RESPONSES TO COMMENTS ON THE DRAFT PROPOSED REMEDIAL ACTION PLAN FOR
OPERABLE UNIT 19 (OU 19) SITE 84 MCB CAMP LEJEUNE NC
04/17/2008
RHEA ENGINEERS & CONSULTANTS

RE: **RESPONSES TO COMMENTS**
 DRAFT PROPOSED REMEDIAL ACTION PLAN (PRAP)
 OPERABLE UNIT 19 SITE 84
 MCB CAMP LEJEUNE, NORTH CAROLINA

FINAL PROPOSED REMEDIAL ACTION PLAN SITE 84, OPERABLE UNIT NO. 19

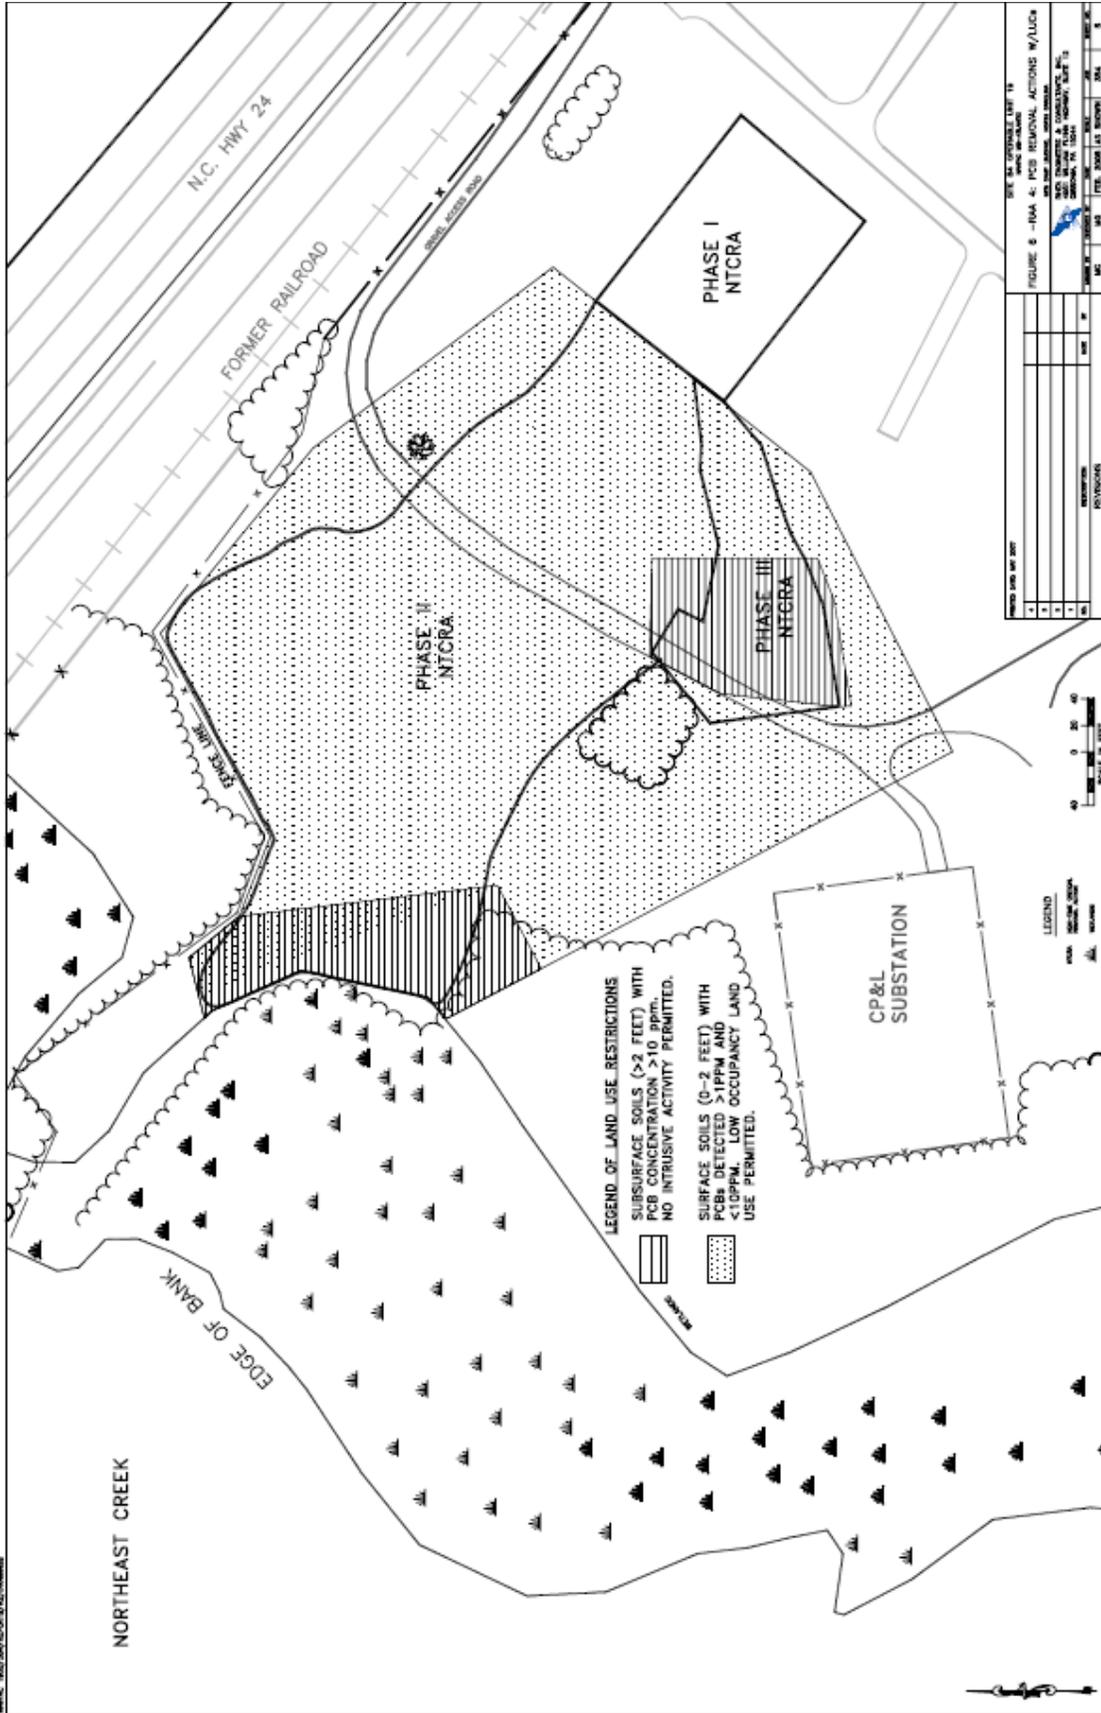
USEPA Comment 19: Figure 3 – Land Use Controls, Page 7 – Please revise title of the Figure to “Land Use Controls Boundary”. Also, if possible include the shaded areas along with the text boxes in the actual Figure in the legend box. The shaded boxes should be preceded by the words “Land Use Restrictions” in the legend. Suggest that this Figure be an entire page and included at the end of the document.

NCDENR Comment 5: Figure 3 of the PRAP dated April 2008 shows a hashed area adjacent to and including the former lagoon area as containing PCB concentrations greater than 10 ppm at depths greater than 2 feet below ground surface. Please clarify, in the PRAP, that only 6 PCB confirmation samples, taken to depth, out of 33 total PCB samples were above 10 ppm and none of the 33 PCB post excavation samples in this hashed area exceeded 50 ppm.

Response: Title has been revised and text boxes have been removed. The Figure has been made an entire page at the end of the document following the glossary.

Response: This information has been added to the PRAP as discussed above.
